ADDENDUM NO. 2

For: Humble Independent School District
AMS / HMS Additions & Renovations
10203 Birchridge Drive
Humble, TX 77338

PREPARED BY: PFLUGER ARCHITECTS

PROJECT NO: 24-042

1 2E02.12 COMPOSITE POWER PLAN - AMS

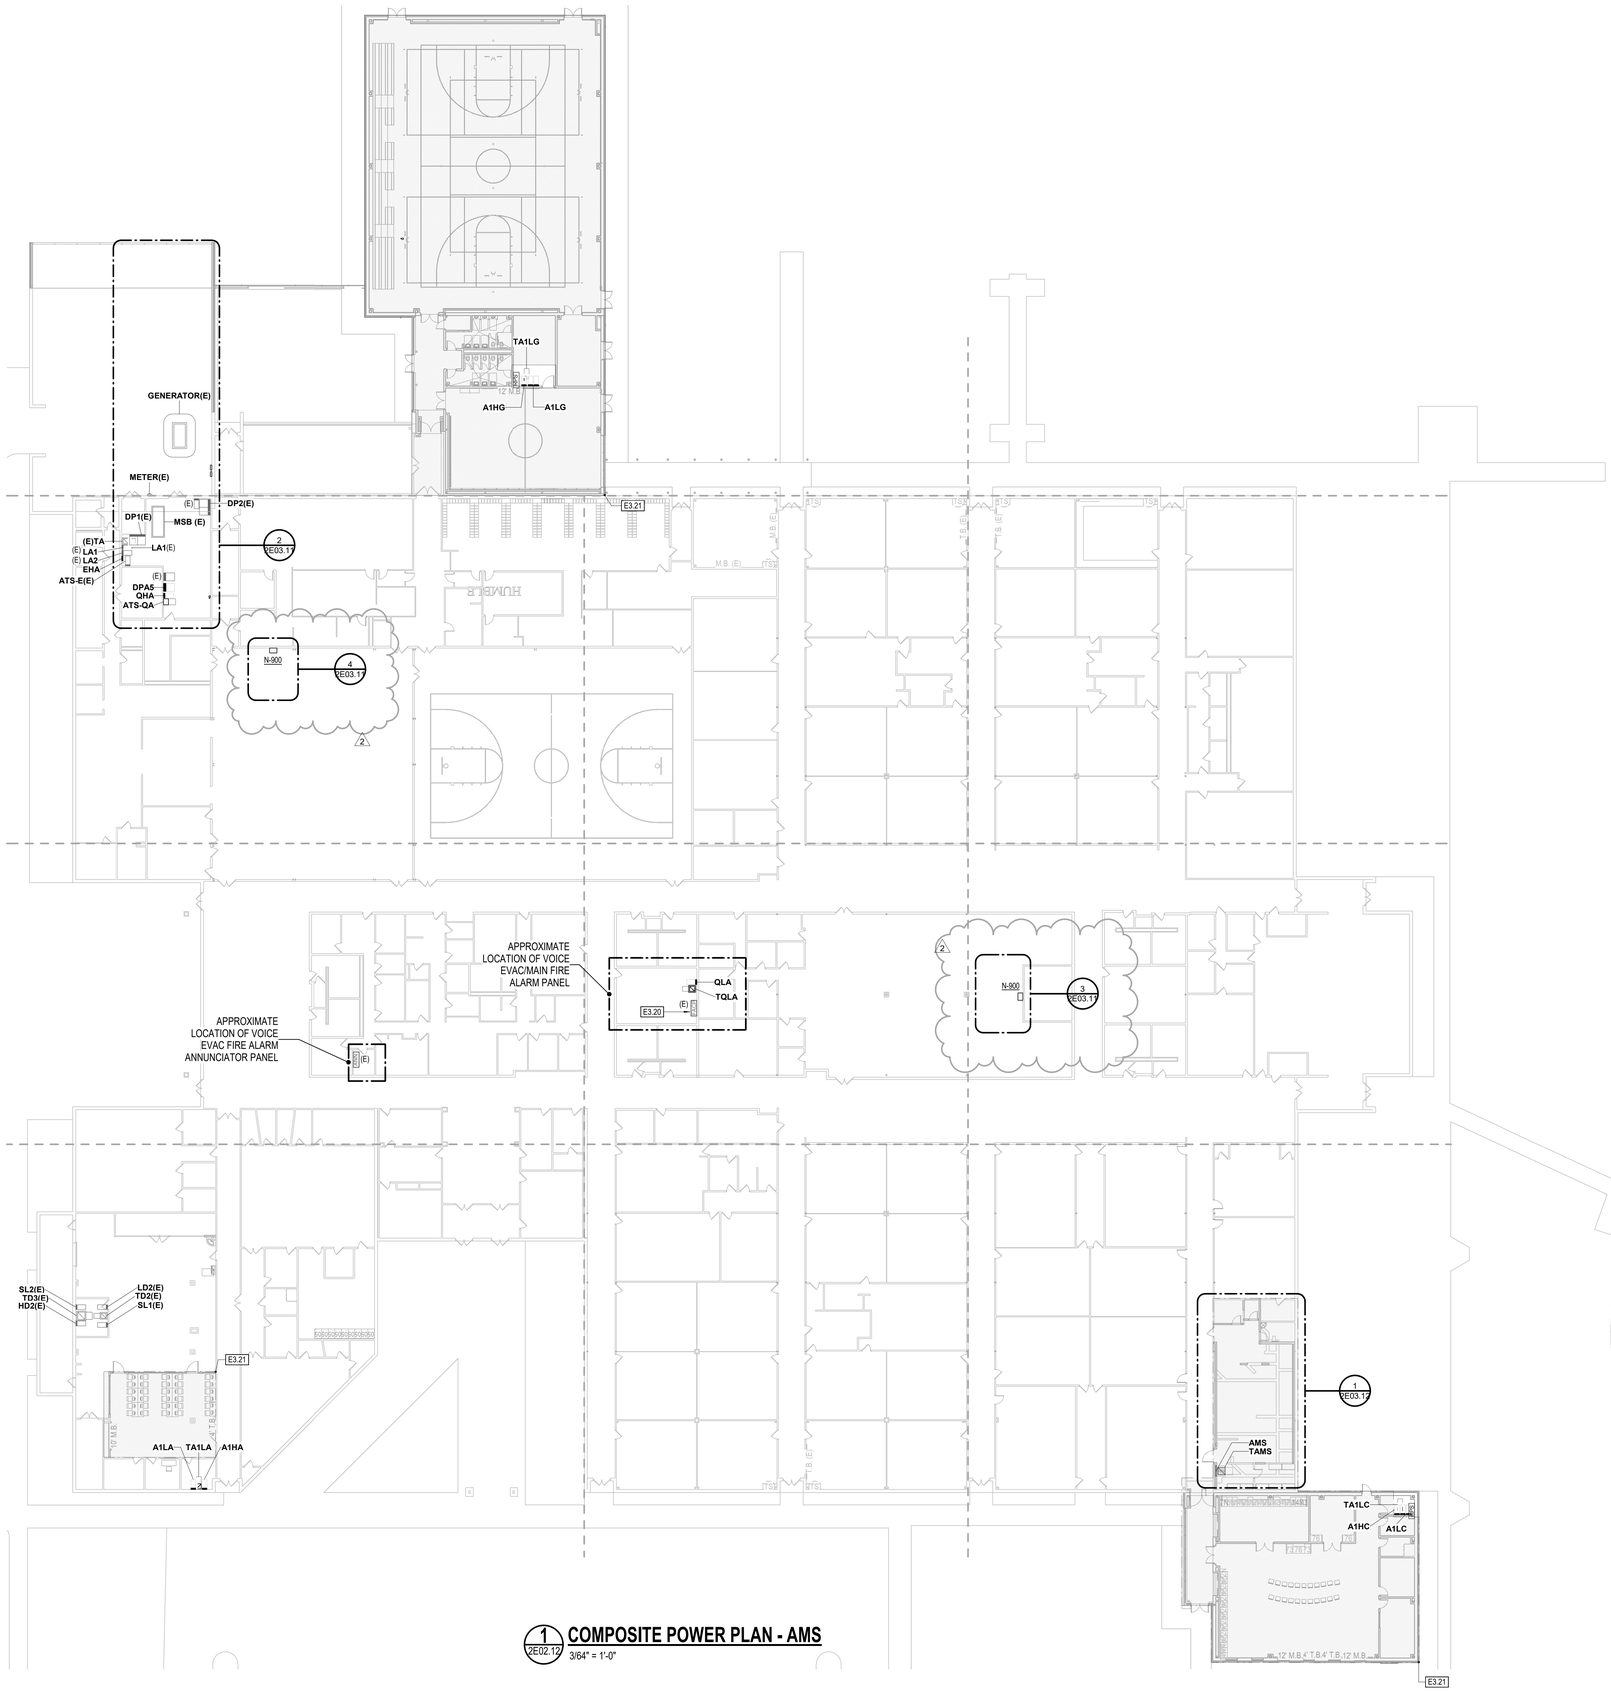
D2-37	2E02.12	Added call-outs. See updaeted sheet.
D2-38	2E02.12A	Added (4) dedicated circutis in shop room. Added eletrical keyed notes E3.23 and E3.24. See updated sheet.
D2-39	2E02.12B	Added SPD2. Only for clarification. See updated sheet.
D2-40	2E02.12D	Added SPD2. Only for clarification. See updated sheet.
D2-41	2E02.12G	Added (1) new dedicated 120V circuit. See updaetd sheet.
D2-42	2E03.11	Added (1) Pump and provided new circuit and power. Relocated pumps. Added (2) enlarged views. See updated sheet.
D2-43	2E04.01	Updated eltrical one-line diagrams. Added eletrical one-line diagram keyed notes 15 and 16. See updated sheet.
D2-44	2E05.01	Updated all eletrical panel schedules. See updated sheet.
D2-45	E4.01	Updated transformer schedule. See updated sheet.
D2-46	E5.01	Updated lighting fixture schedule. Updated Contactors shcedules. See updated sheet.

2 2P03.01 PLUMBING PLAN - AMS - FOOD SERVICE
1/4" = 1'-0"

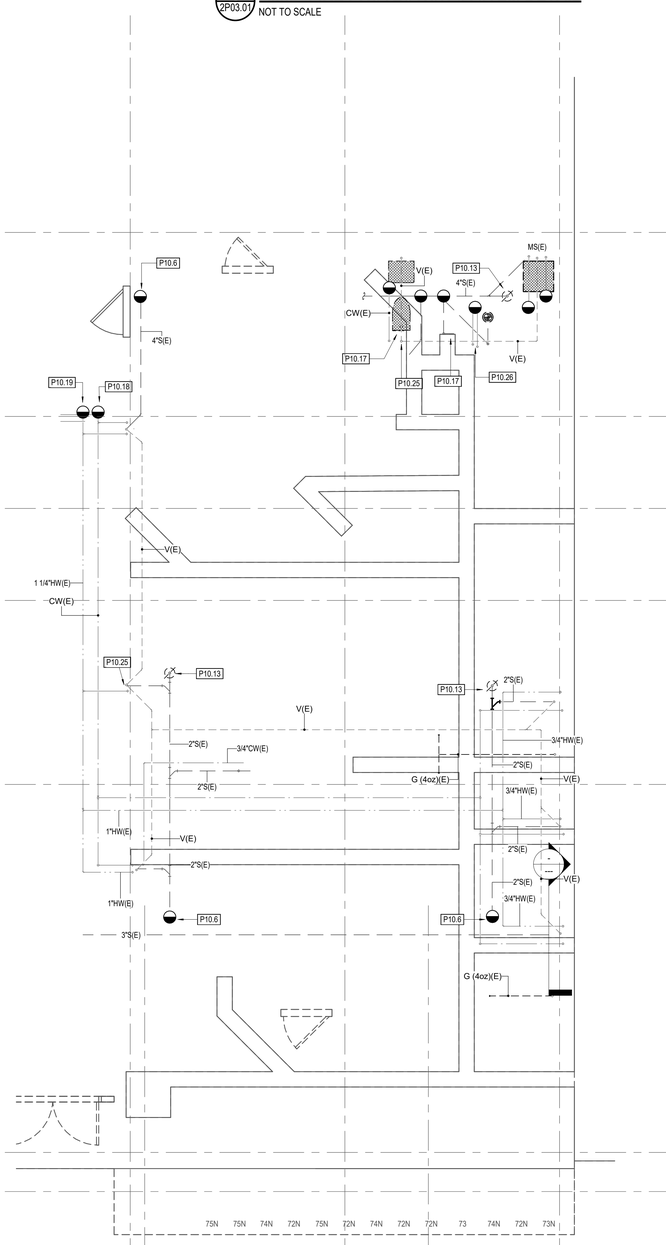
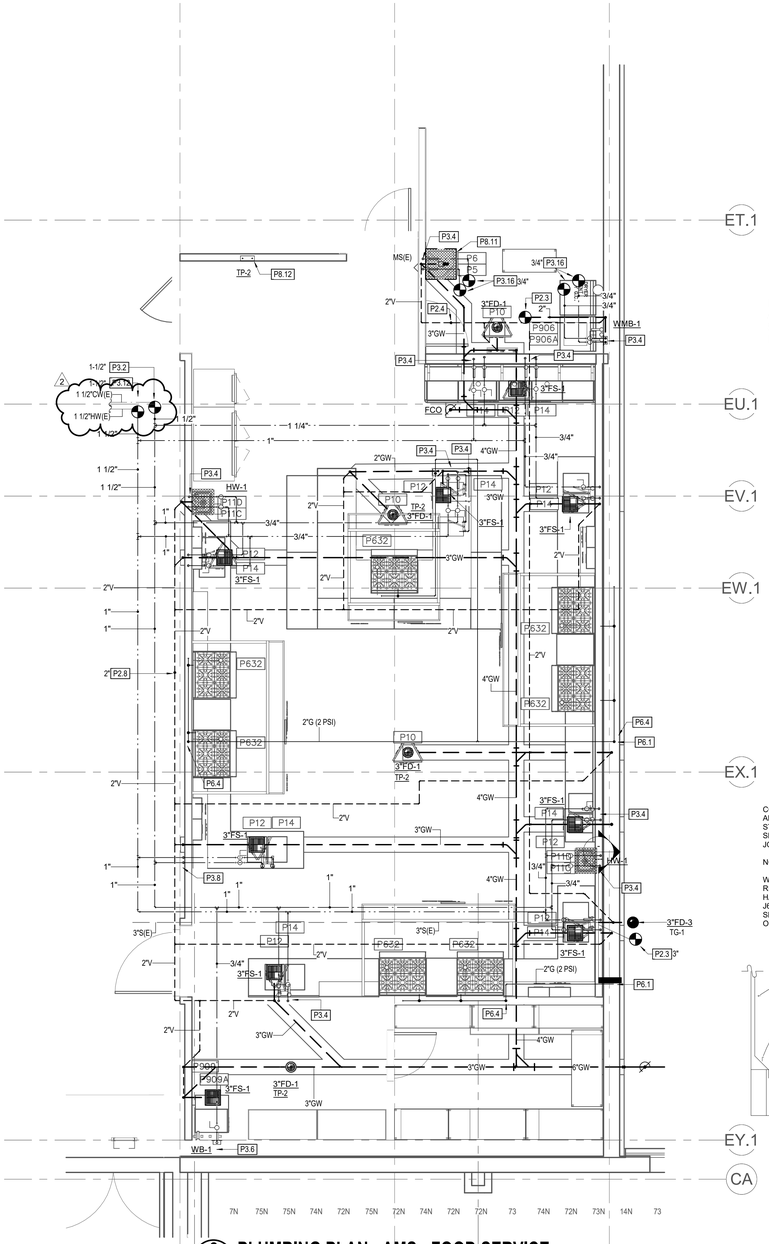
D2-47	E6.02	Added sheet in its entirety.
D2-48	2P03.01	Added existing cold lines with sizes. Added keynote to cold and hot water line.
D2-49	2T02.02G	Relocated A/V inputs for mobile rack.
D2-50	T6.01	Removed Details 1 and 2 - replaced with new Detail 1 for access control.

1 1M02.03 **MECHANICAL ROOF PLAN - HMS**
1" = 20'-0"

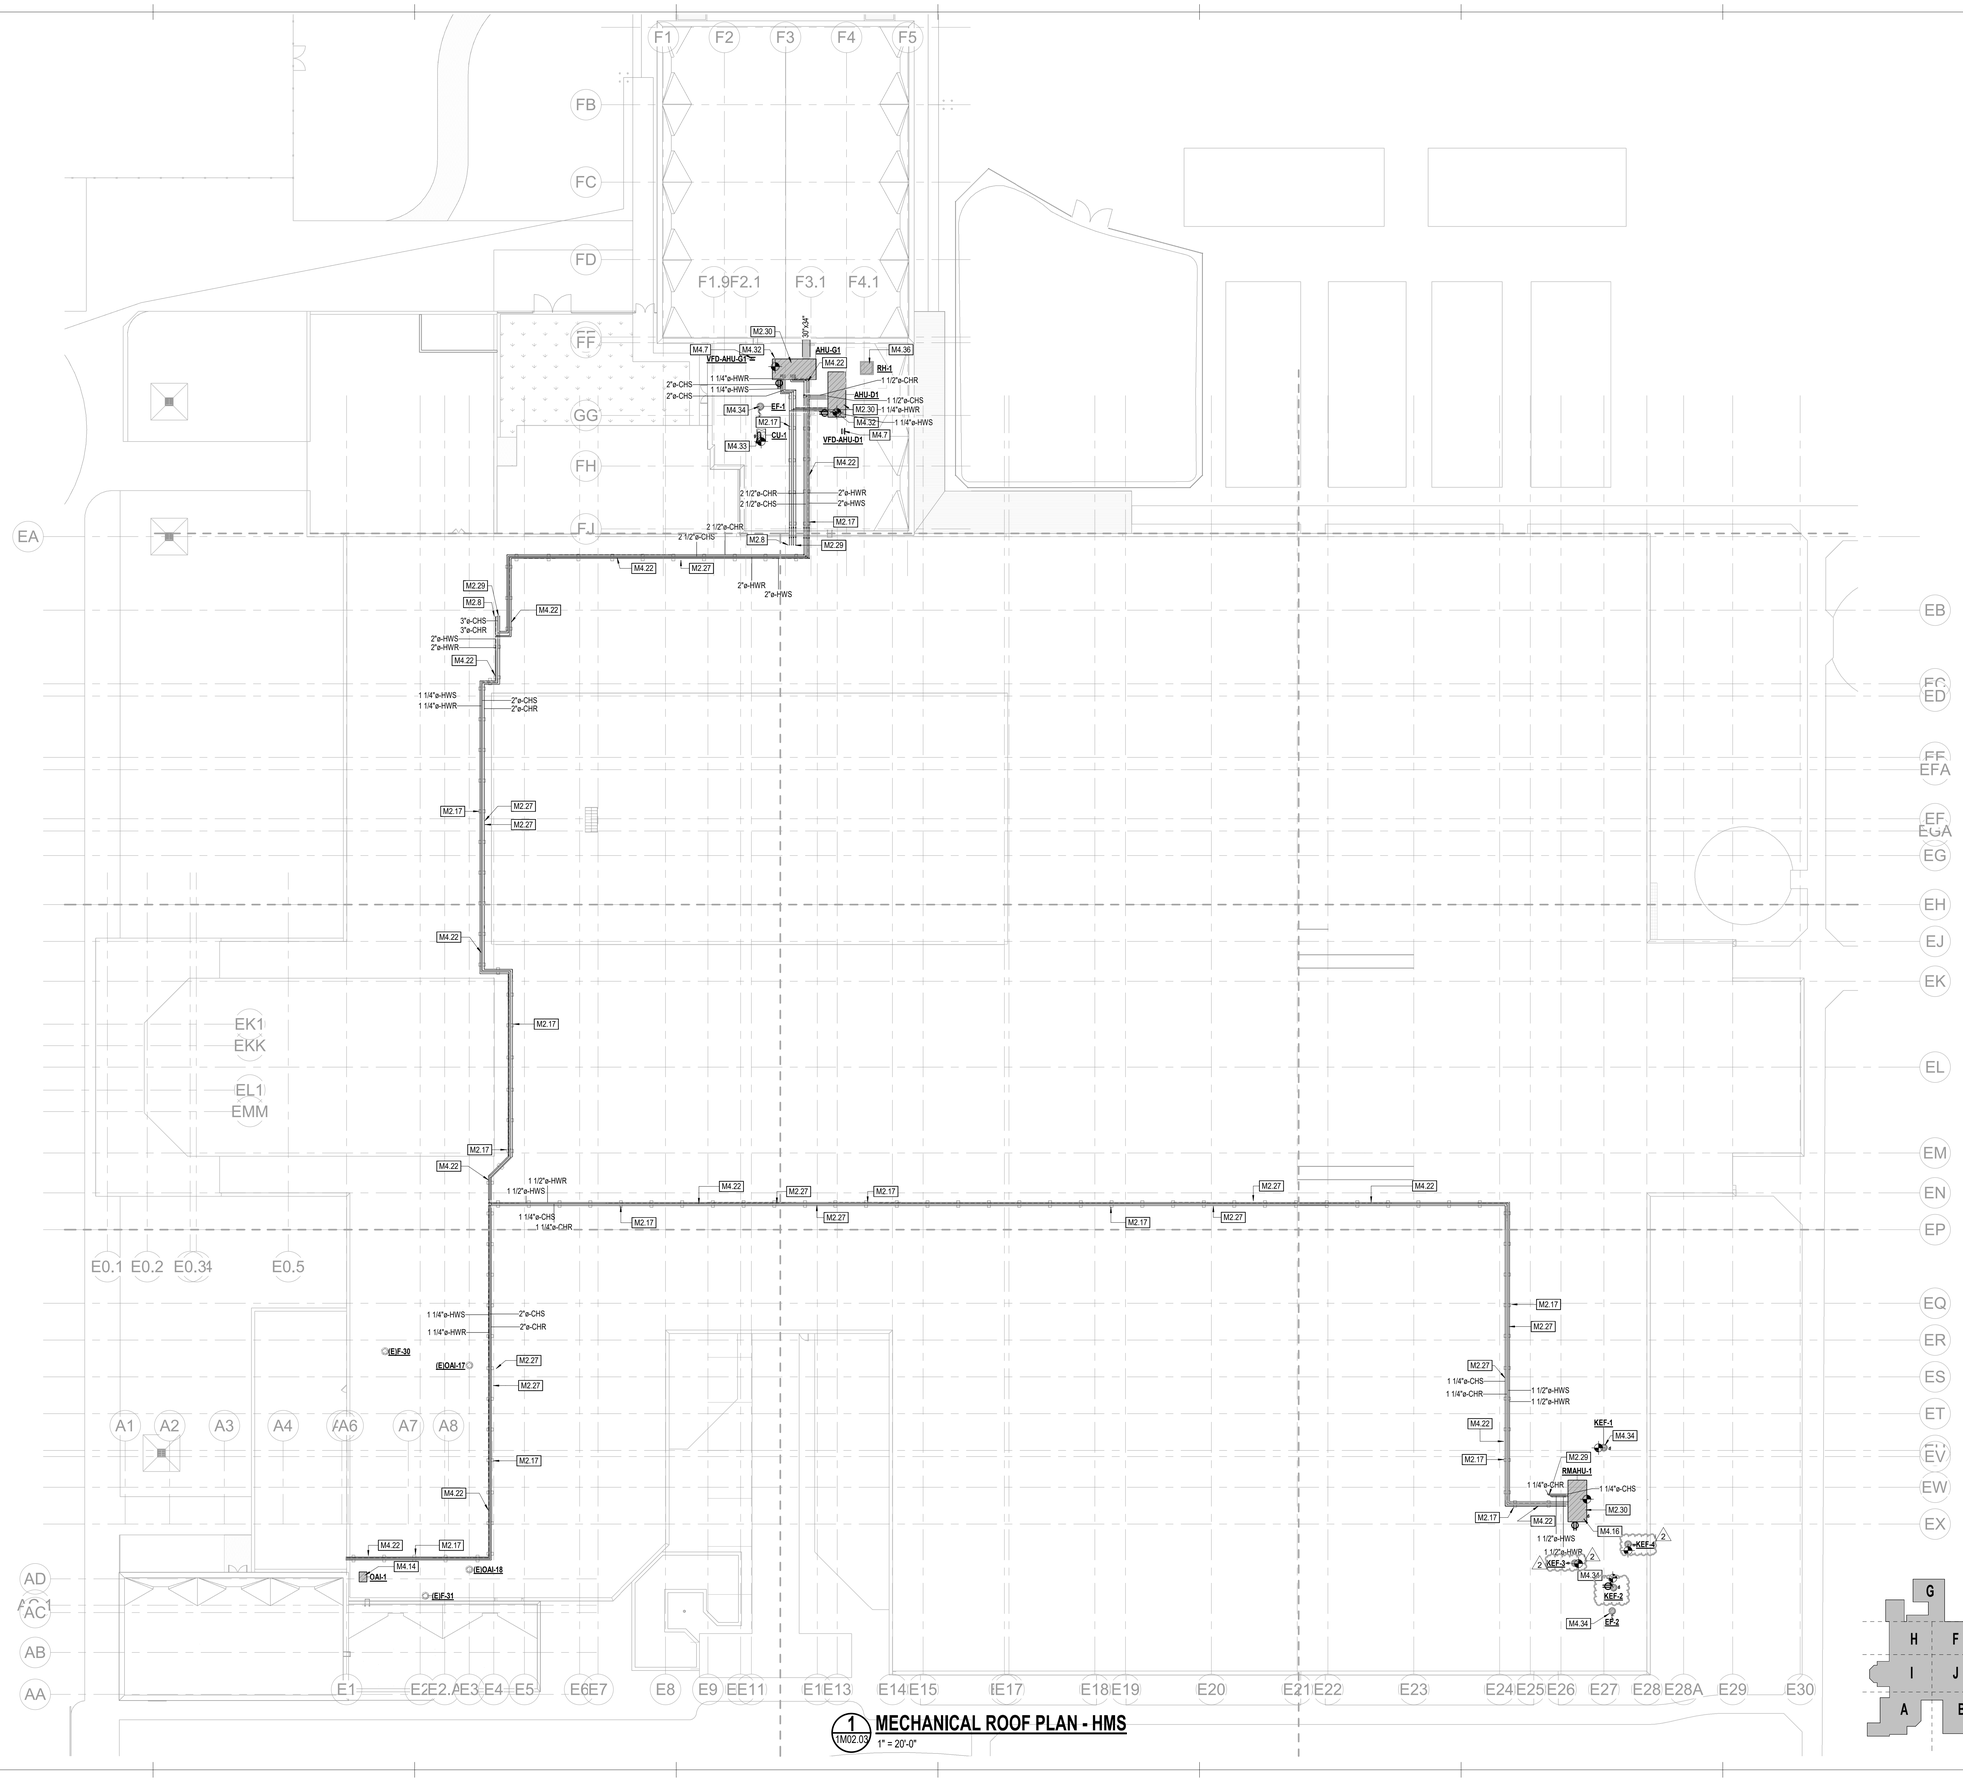
ITEM	SHEET	DESCRIPTION
HUMBLE MIDDLE SCHOOL		
D2-1	1M02.02D	Added Air Purification Unit. Added Keyed note M4.3
D2-2	1M02.02I	Added Air Purification Unit. Added Keyed note M4.3
D2-3	1M02.03	Added KEF-3 and KEF-4.
D2-4	1M03.11	Modified exhaust ductwork and rerouted connections so each hood is served by a dedicated fan.
D2-5	1M05.01	Corrected pump schedule: flow GPM and pump size for P-1. Fan Schedule: Modified KEF-2; added KEF-3 and KEF-4. Clarified bipolar ionization model number and provided notes in RMAHU schedule and SZ AHU Schedules.
D2-6	1E01.14	Updated roof fans. Added (1) fan. See updated sheet.
D2-7	1E02.02	Added call-out, added eletrical keyed note E10.3 to provide new GTDs and emergency circuit to all existing egress and exit lights in building. See updated sheet.
D2-8	1E02.02A	Updated lighting fixture types in tech room and added circuit to exterior wall pack. Added call-out. See updated sheet.

1 / 1E02.02B LIGHTING PLAN - FIRST LEVEL - HMS - SEGMENTS 'B' & 'C'

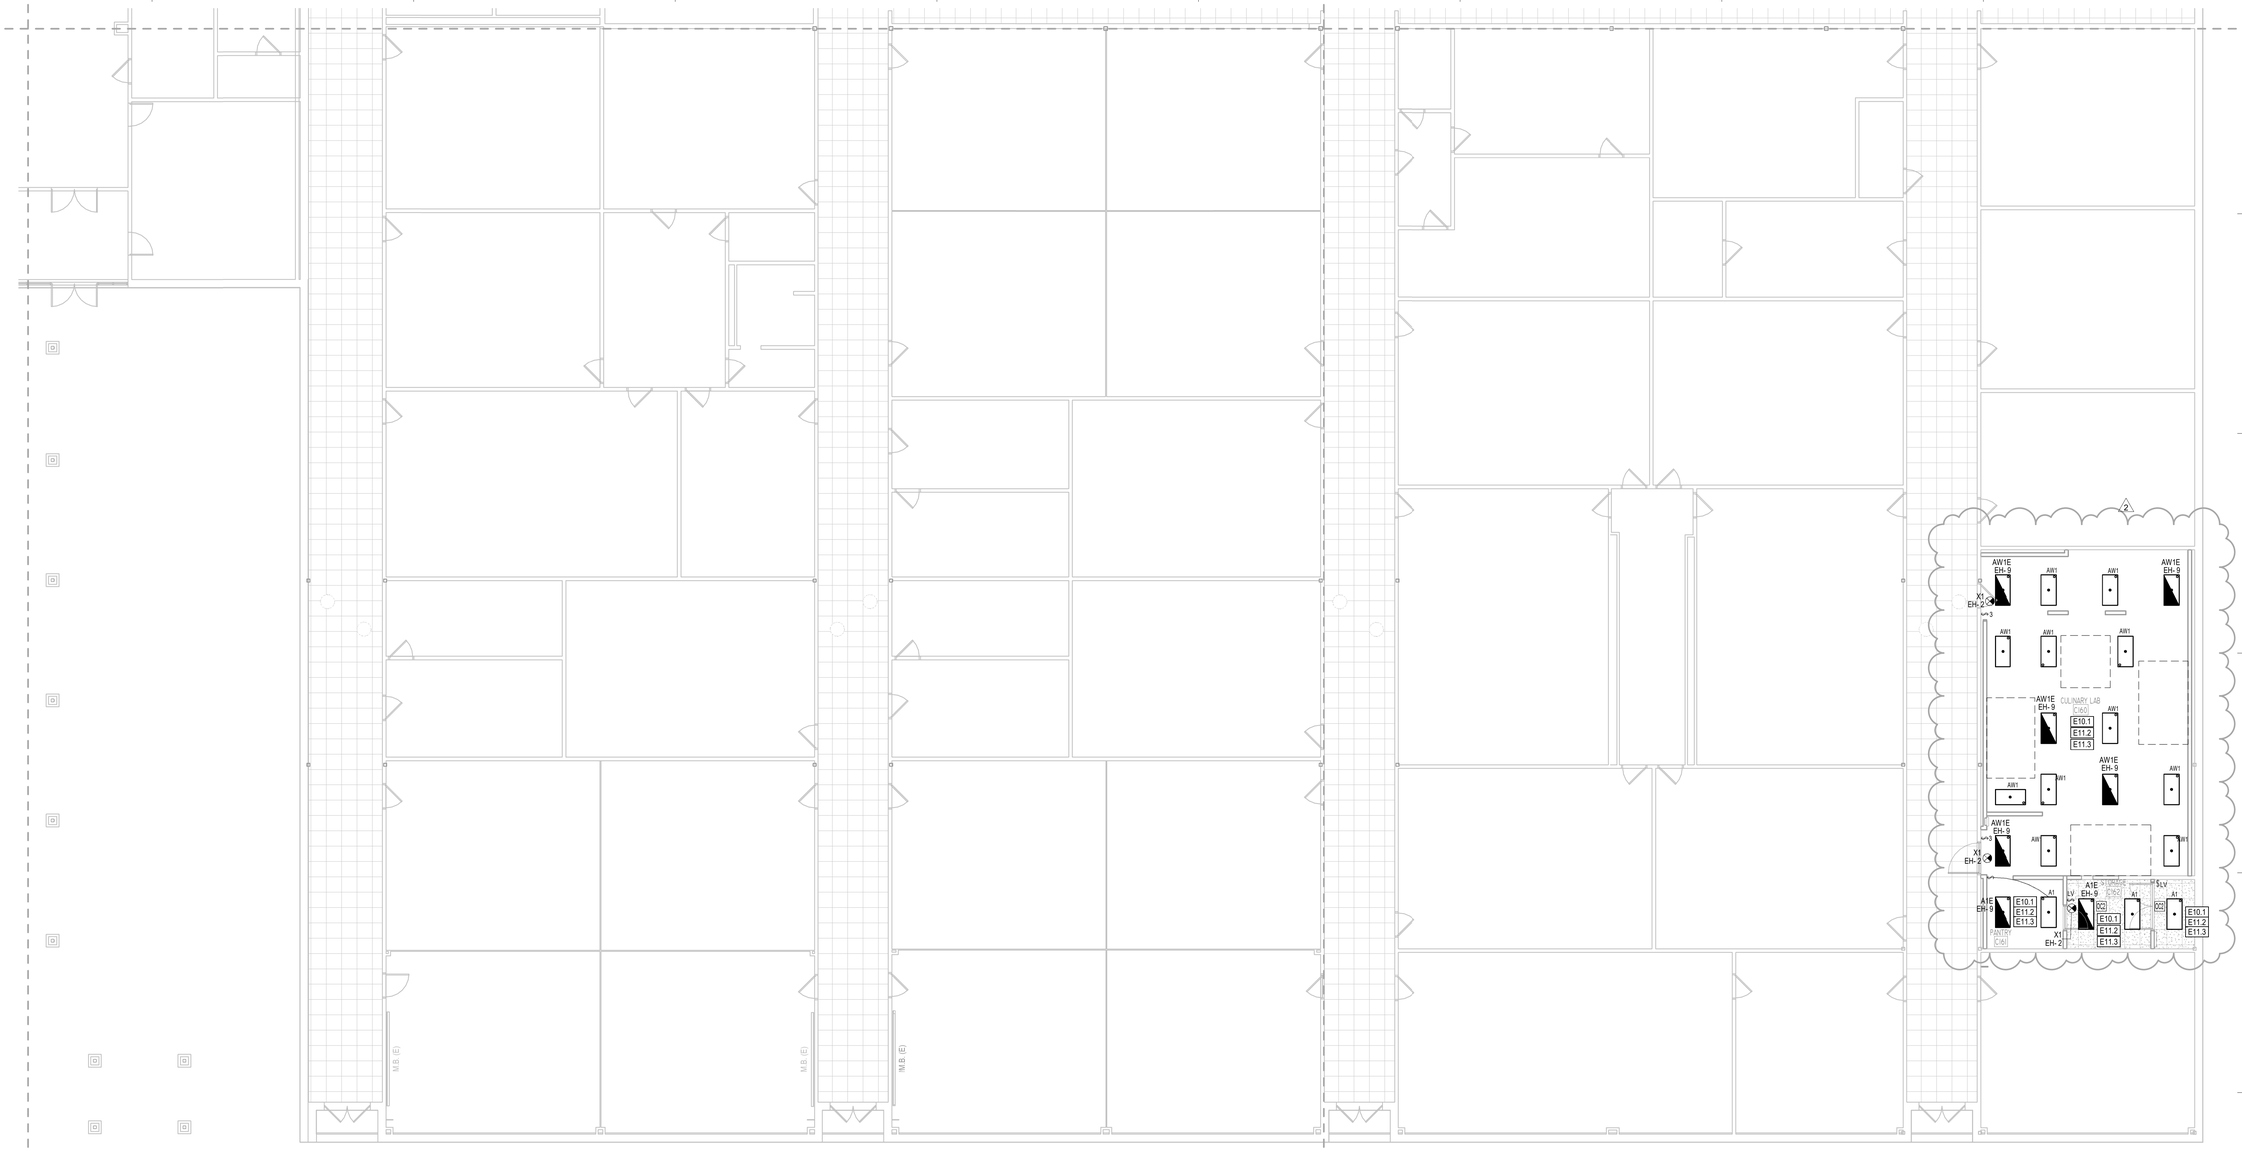
D2-9	1E02.02B	Updated lighting fixture types in culinary lab. See updated sheet.
D2-10	1E02.02G	Added wall pack fixture circuits and updated fixture types. See updated sheet.
D2-11	1E02.12	Added call-outs. See updaeted sheet.
D2-12	1E02.12G	Added (1) new dedicated 120V circuit. See updaetd sheet.
D2-13	1E03.14	Added sheet in its entirety.
D2-14	1E04.01	Updated ATS size. See updated sheet.
D2-15	1E05.01	Updated all eletrical panel schedules. See updated sheet.
D2-16	E4.01	Updated transformer schedule. See updated sheet.
D2-17	E5.01	Updated lighting fixture schedule. Updated Contactors shcedules. See updated sheet.
D2-18	E6.02	Added sheet in its entirety.
D2-19	1P03.01	Added existing cold lines with sizes. Added keynote to cold and hot water line.
D2-20	1T02.02G	Relocated A/V inputs for mobile rack.
D2-21	T6.01	Removed Details 1 and 2 - replaced with new Detail 1 for access control.
ATASCOCITA MIDDLE SCHOOL
